## Response to Reviewers' Comments for 'Brief Communication: Rise of the Guadalupe River- A Multifaceted Post Event Analysis of the July 4, 2025, Flood in Central Texas'

### Reviewer #2:

Figure 1

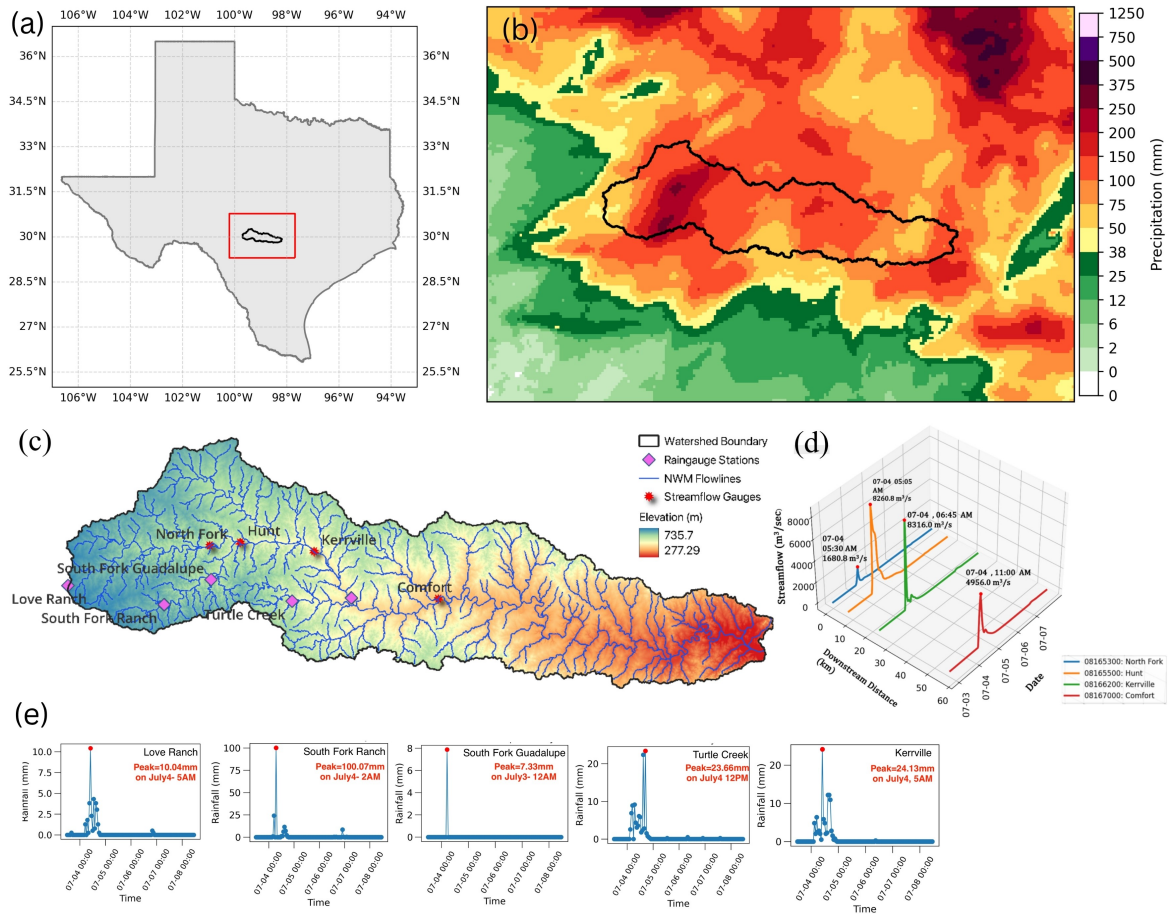
- Fig 1c: I suggest using different colours for rain gauge stations and streamflow gauges (currently

Response: Thank you for your suggestion. We have updated the plot (Fig 1c)

Figure 2

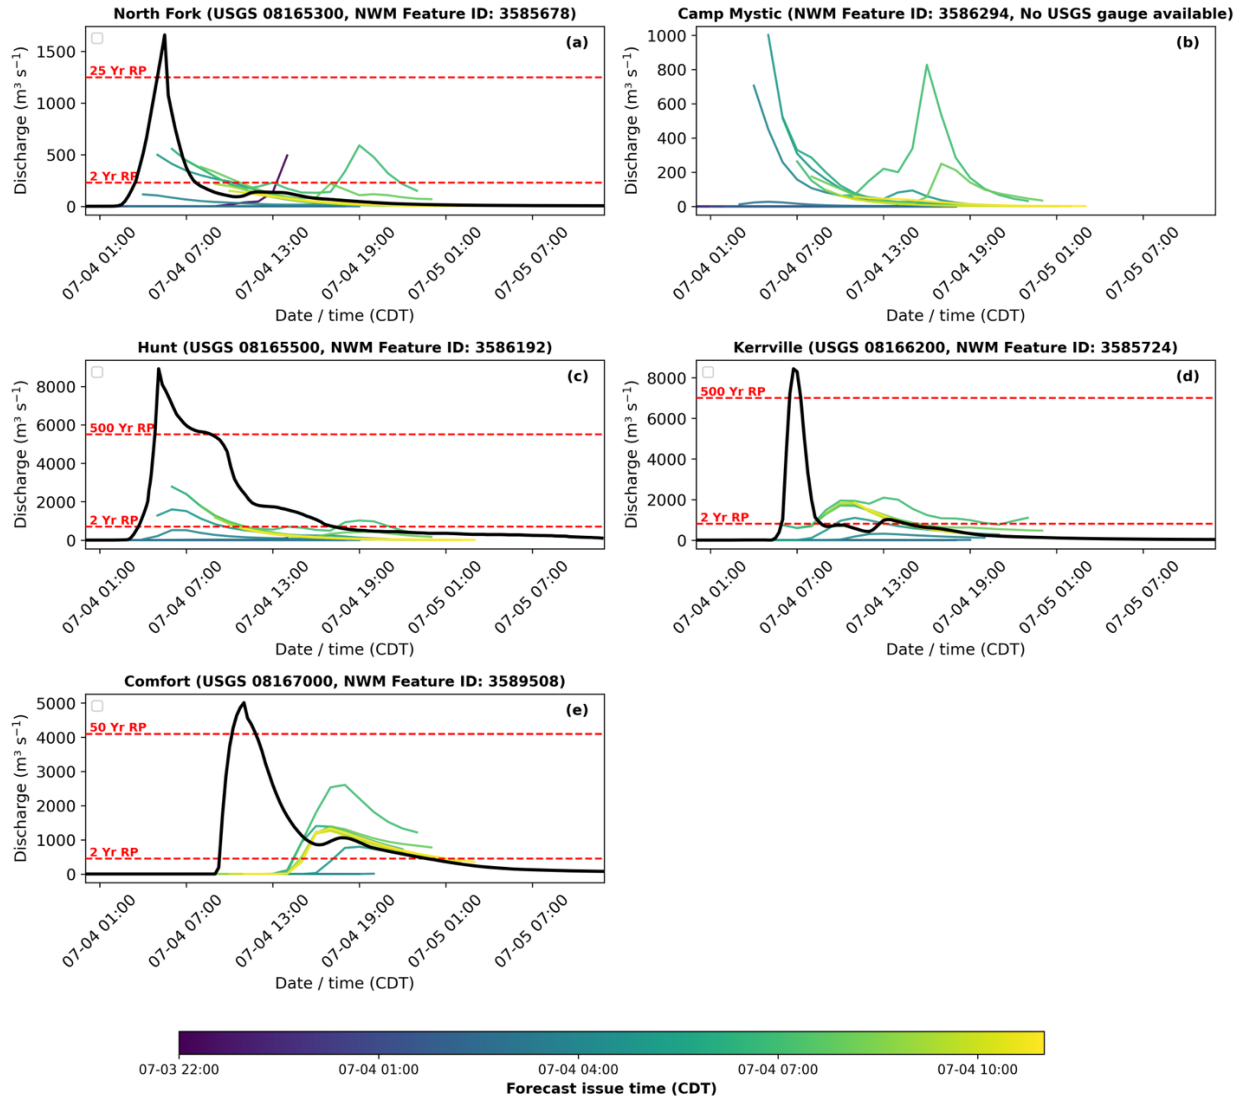
Regarding panel e, it is confusing that it does not have any USGS gauge readings and no return periods. This “station” (?) is also not shown in Figure 1 panel c and therefore leads to confusion. Also the subtitle is not informative and the time interval and coverage is different. Generally, it could be an idea to use a colour scale that intuitively changes colour with lead time (for example increasing colour intensity), as now certain lead times have the same colour and cannot be distinguished. Also the time range can be shortened to only show relevant data. This might allow the panel to be a big larger and the data to be more visible.

Thank you for your question. Panel (e) in Figure 2 indicates the National Water Model short-range forecasts near Camp Mystic, where the maximum casualties occurred. There was no USGS gauge available at that location. We have updated the caption in Figure 2 accordingly.

Based on your suggestion we have also updated the color scheme, and time range in Figure-2.

#### Figure 3

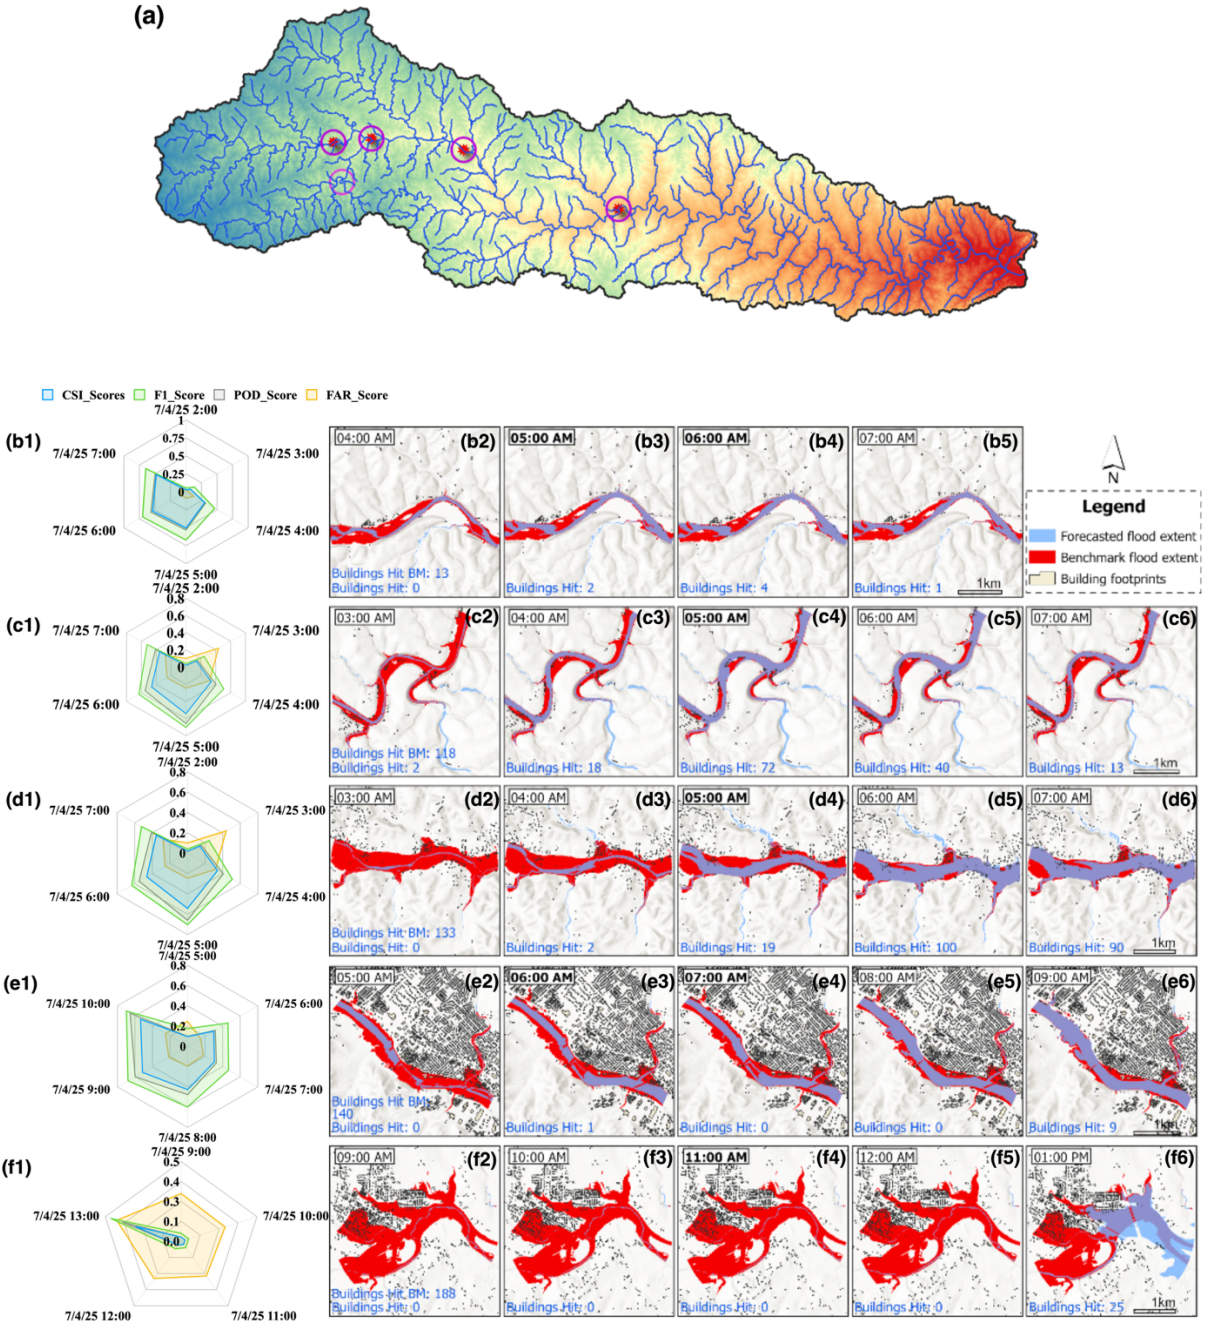
Panel numbering is missing for upper map. In this panel, please add the name of the fifth purple circle and explain this is Camp Mystic (I assume). Also, please center the purple circle for the gauge at Hunt in top map.

Please use the name order of gauge names as in Figure 2, e.g. in Fig 2 panel e is Camp Mystic and here (Fig 3) panel b. I prefer the station order used in Figure 3, as it follows the downstream progression of the catchment flow and therefore improves interpretability. I suggest using this same ordering consistently across all figures and throughout the text. It is

The text in the a-e1 panels is very small and I suggest to increase the size where possible. I do like the way these panels visualise the different metrics per FIM.

For the legend of panels a-e2-6, is flood extent the forecast flood extent? If so, suggestion to change to “Forecasted flood extent”.

The colour of the building footprints makes is very hard to see them, especially at this scale. I recommend to fill them and choose a colour combination that makes them easy distinguishable.

Response: Thank You for your comment. We have added the panel number, named the fifth purple circle and put the purple center at the center of the Hunt gauge.

Response: Thank you for your suggestion. We have updated the plot

Response: We have updated the plot

Thank you. The legend has been updated.

Thank you. The building footprint markers have been filled in light grayish yellow (#F3EDD3) and outlined with 80% gray to make them more seeable. Also, the text in the lower left of each panel has been changed to light blue to make them more visible after changing the symbol of building footprints.

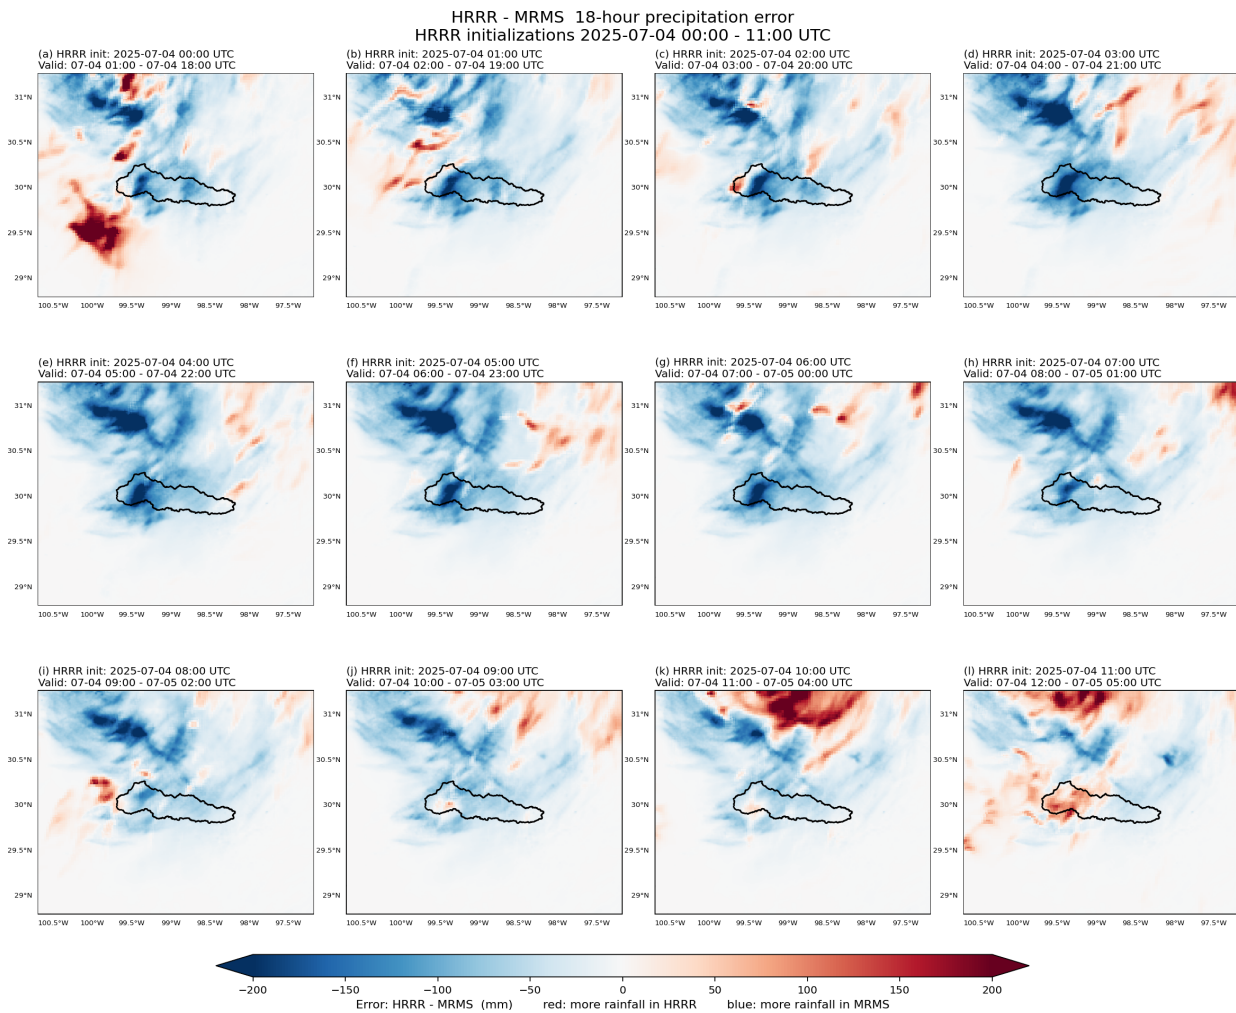
Figure S3 states “six-hour rainfall accumulation at 8:00 AM derived from MRMS (1 km) Pass 2 observations and HRRR (3-km) forecasts issued at successive lead times, from 0 hour through 7-hour lead time”, however the plots shown (panel b-h) are from 2:00 AM – 20:00 PM, which do not seem to match the mentioned lead times. Also, a difference of plots could be more informative to see the magnitude of differences in specific locations than leaving this to the estimation skills of the reader.

We agree with the reviewer on both points and thank them for flagging the caption/lead-time inconsistency and for suggesting a direct difference plot. Figure S3 has been replaced. The new figure shows the HRRR – MRMS error for the full 18-hour HRRR cycle across twelve successive initializations on 2025-07-04 (00:00–12:00 UTC). Red indicates more rainfall in HRRR, blue more in MRMS, and each panel title gives the init time and the 18-hour valid window. The updated caption is below.

Figure S3. Spatial error (HRRR – MRMS) in 18-hour accumulated precipitation over the Guadalupe (HUC8) basin and a 1° buffer, for twelve successive HRRR initializations from 2025-07-04 00:00 UTC through 11:00 UTC. Each panel (a-l) shows the difference field for one initialization: the 18-hour HRRR forecast accumulation (regridded to the MRMS grid) minus the matching 18-hour MRMS Pass-2 hourly QPE sum over the same valid window. All values are in mm. A common symmetric scale ( $\pm 200$  mm) is used across panels; red denotes more rainfall in HRRR, blue more rainfall in MRMS. The black outline marks the HUC8 boundary.
